Service Note		
Product	Description:	Service note no.
WIZARD2	ADC malfunction after power on	720 10 T026

Fig.1.

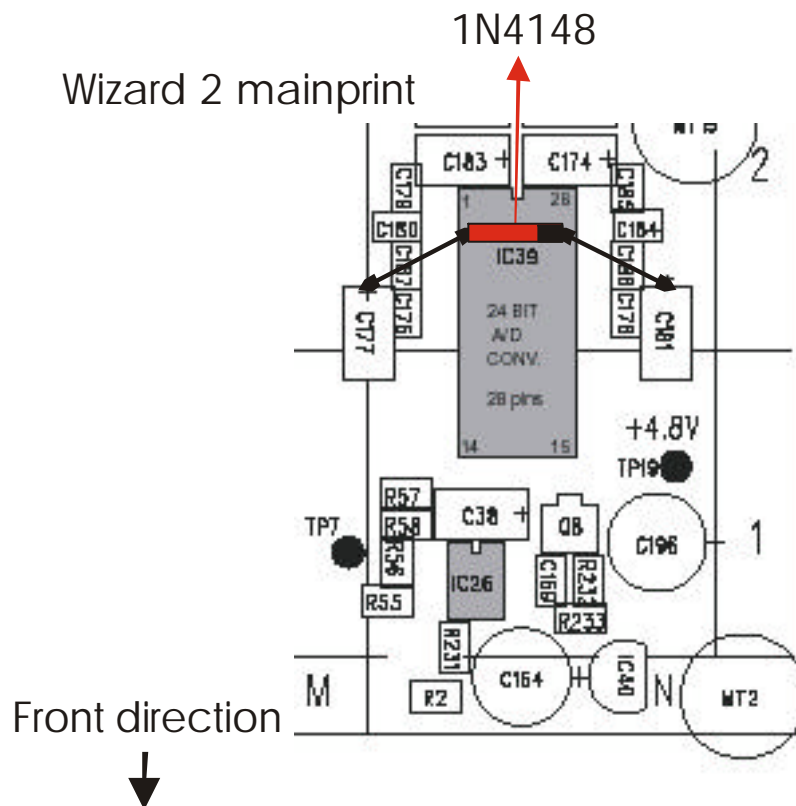
A combination of potential overshoot on the PSU +5V during power ON and a sensitive local power design at the AD converter means that the ADC can brake and be malfunctioning after power ON cycle (no audio through ADC).

The solution is to mount a diode(1N4148) between the digital and analog +5V on the ADC. The PSU's must be production tested to make sure that the +5V is adjusted to 5.18V +/- 0.02V.

1. Make sure to power off the unit.
2. Solder the leaded diode 1N4148 like shown here in fig.1.
